RE: Development Application Mod2021/0733 – 5 Commonwealth Parade Manly. Proposed s4.55 modifications to current consent DA436/2008 including an increase in height above the MLEP height plane over a relatively small area. The s4.55 Modifications primarily comprise a reduced basement level and excavation in response to concerns of neighbours to minimise risk, and improvements to pedestrian and road safety and Front elevation.

1.0. Issues and Overview

Above – Photo 1 – Current Consent Commonwealth Pde. Photo 2 – Proposed s4.55 (with approved shown in red dots)

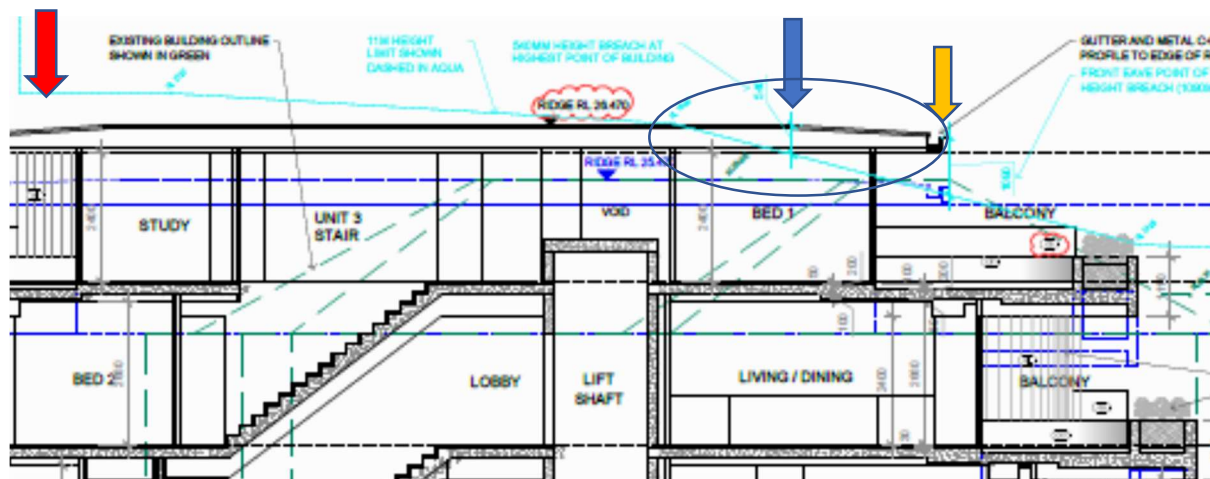
COMMENT: The deletion of the basement access entry and ramp results in reduction in risks, improved vehicle safety and improved pedestrian access.
